**PROJECT NO. TR066952-(5)
VALLEY VINEYARDS PROJECT
(FIFTH SUPERVISORIAL DISTRICT) (3-VOTES)**

The Valley Vineyards project site is located at the intersection of Bouquet Canyon Road and 87th Street West in the Leona Valley Zoned District. The project site is 292 gross acres and within the A-2-2 (Heavy Agricultural-Two Acres Minimum Required Lot Area) Zone.

**DRAFT FINDINGS OF THE REGIONAL PLANNING COMMISSION
COUNTY OF LOS ANGELES
PROJECT NO. TR066952-(5)
VESTING TENTATIVE TRACT MAP NO. 066952**

Date 11-19-2014

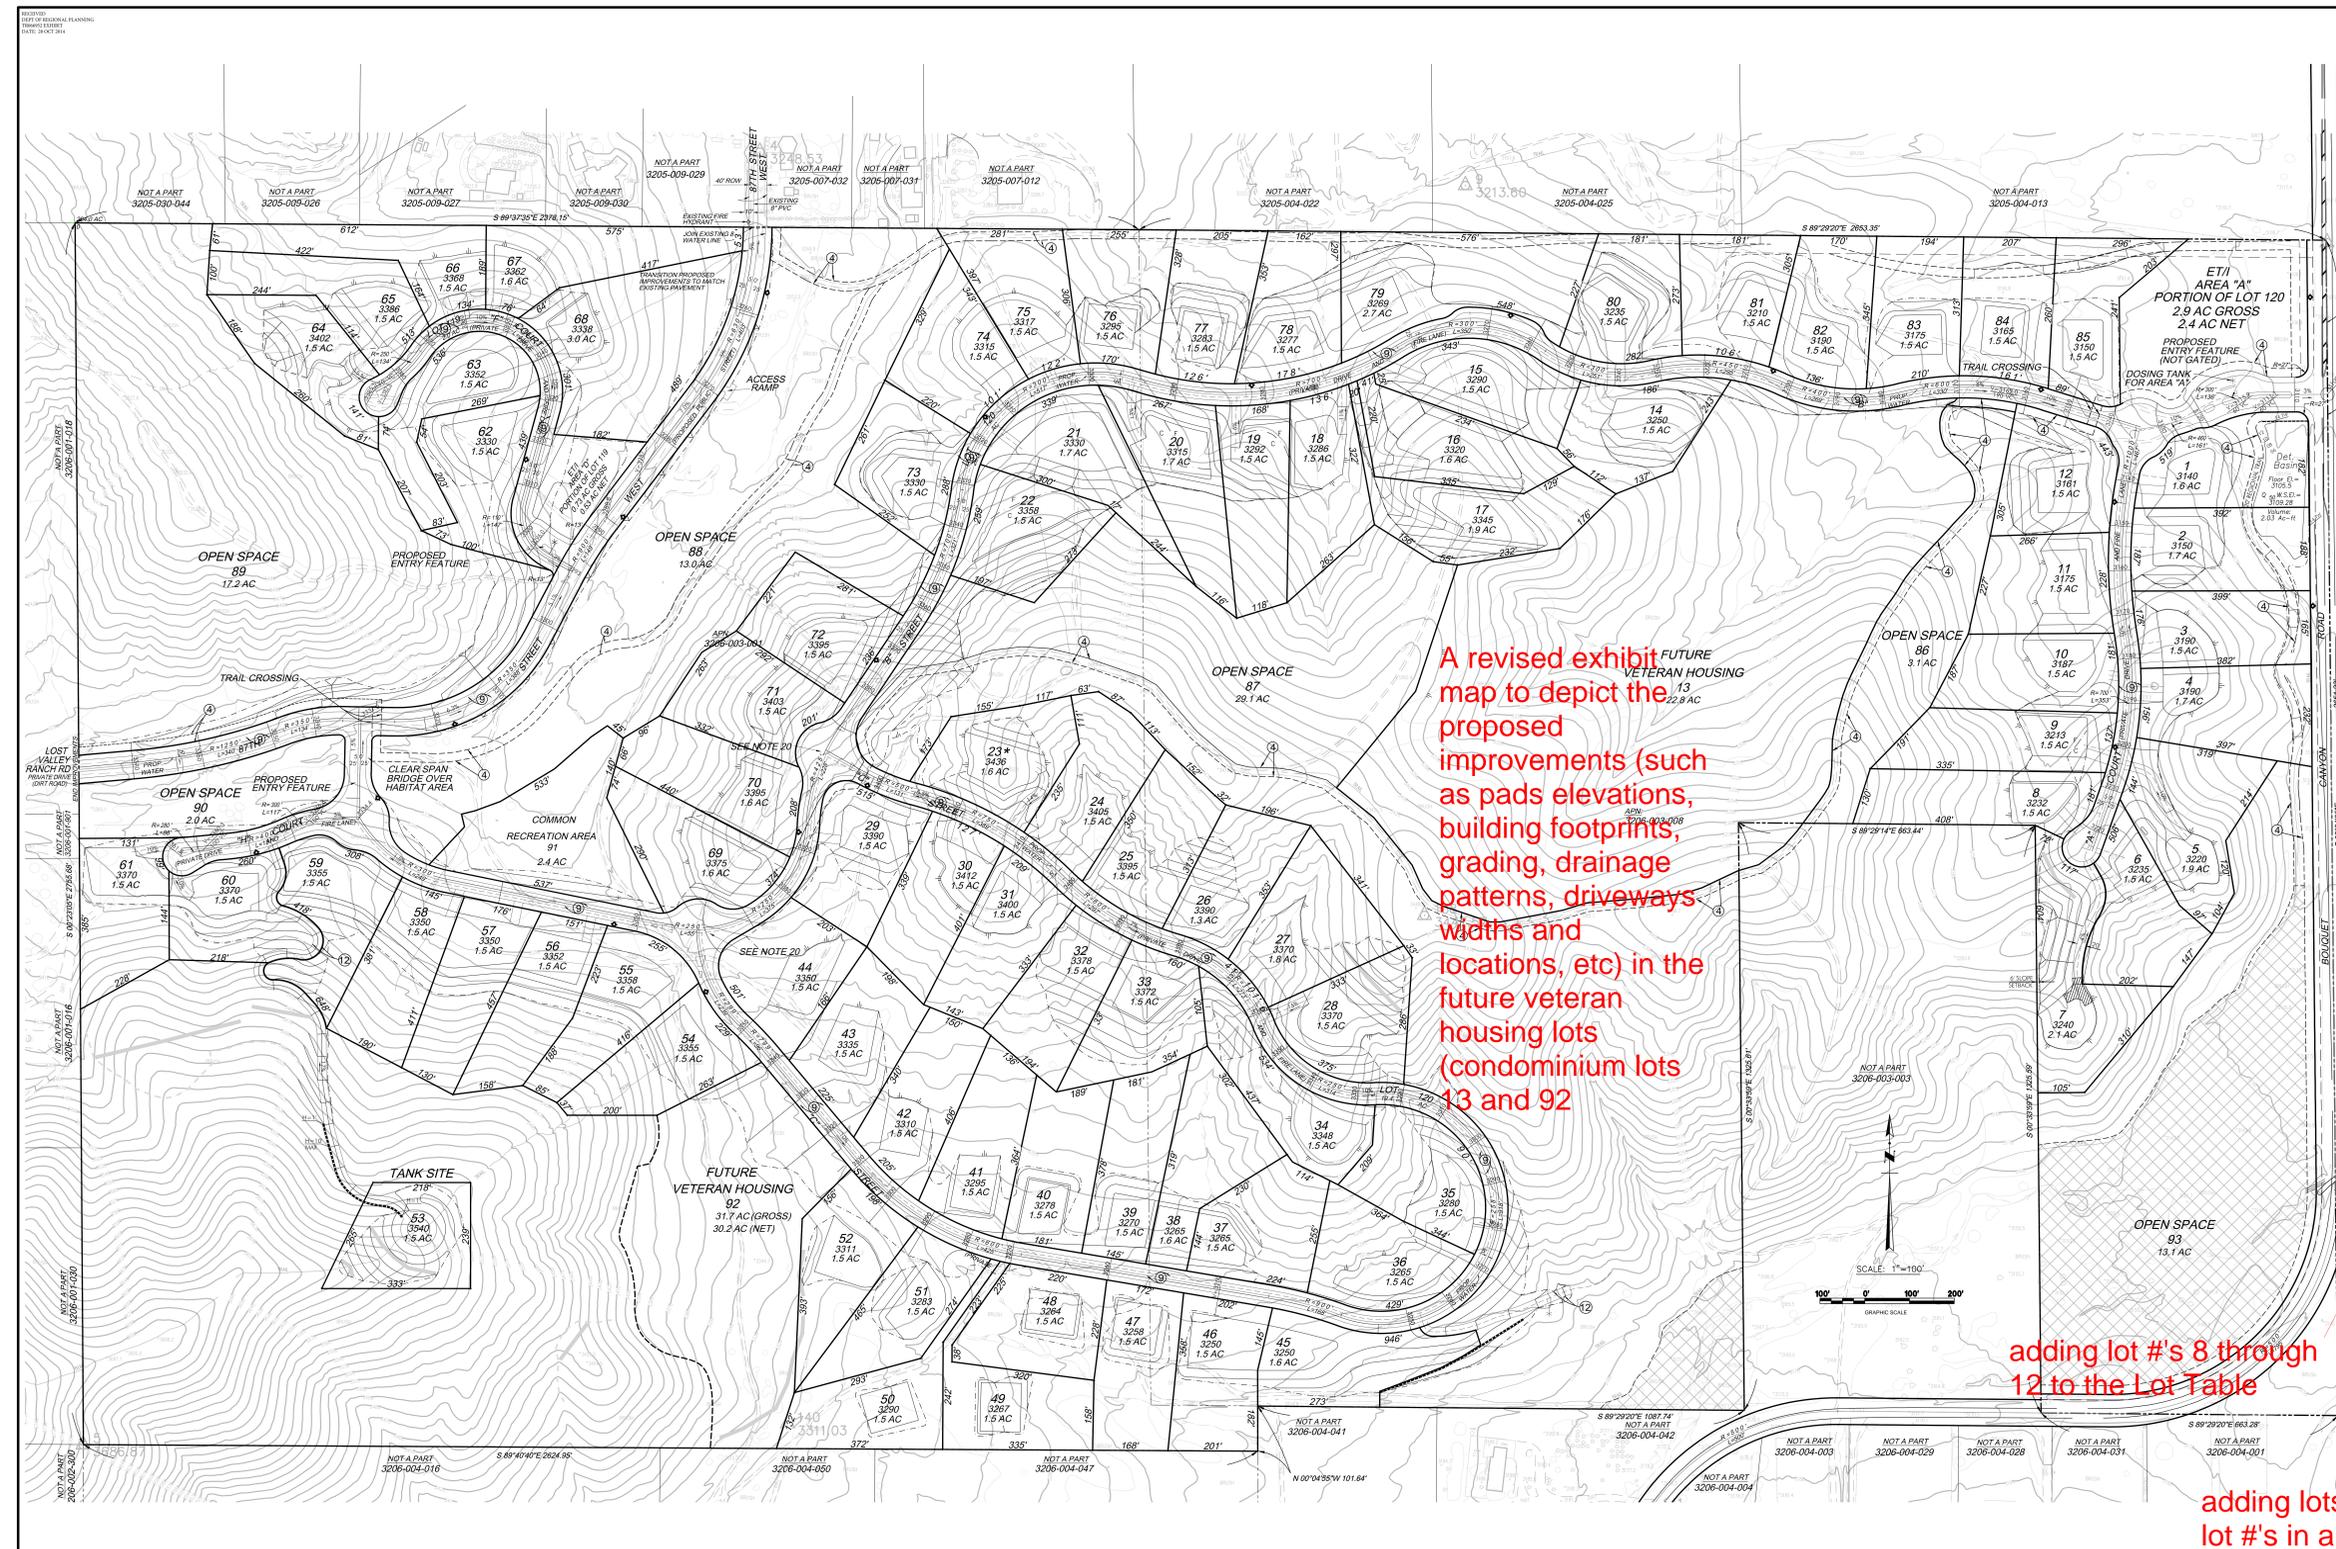
A revised exhibit map to depict the proposed improvements (such as pads elevations, building footprints, grading, drainage patterns, driveways widths and locations, etc) in the future veteran housing lots (condominium lots 13 and 92

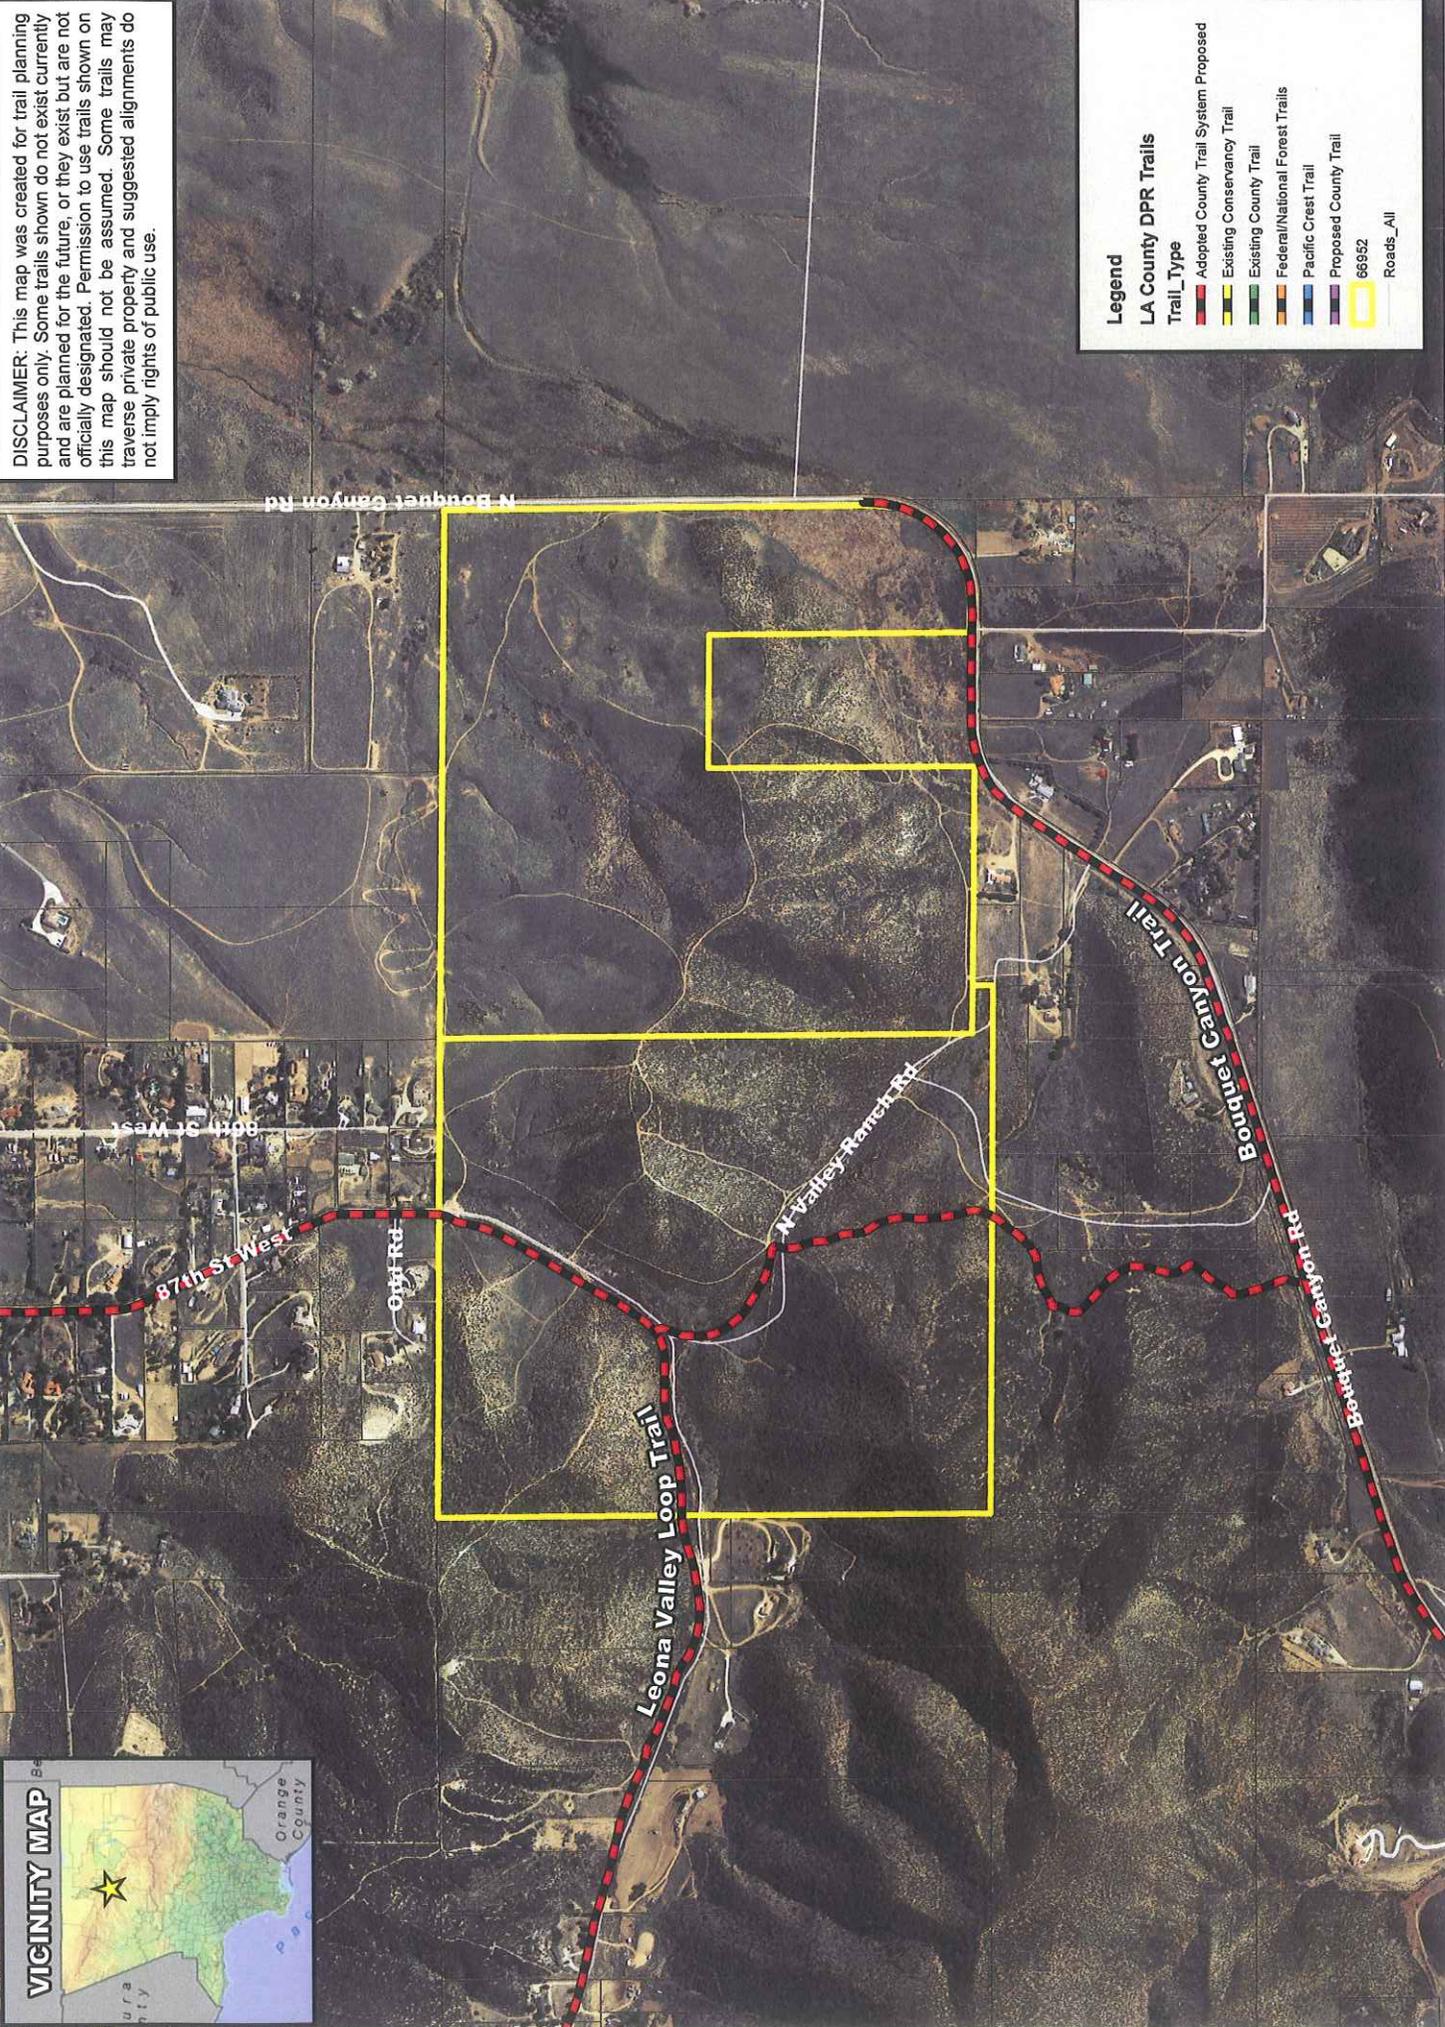
X **Map is on HOLD**

X **Contact Park Planner to discuss trail requirements**

Further research and clarification is needed to ensure the proposed trails will provide improved trail access and connectivity. Please contact Park Planner, Robert Ettleman, at (213) 351-5134 or rettleman@parks.lacounty.gov to discuss map revisions as they pertain to trail requirements.
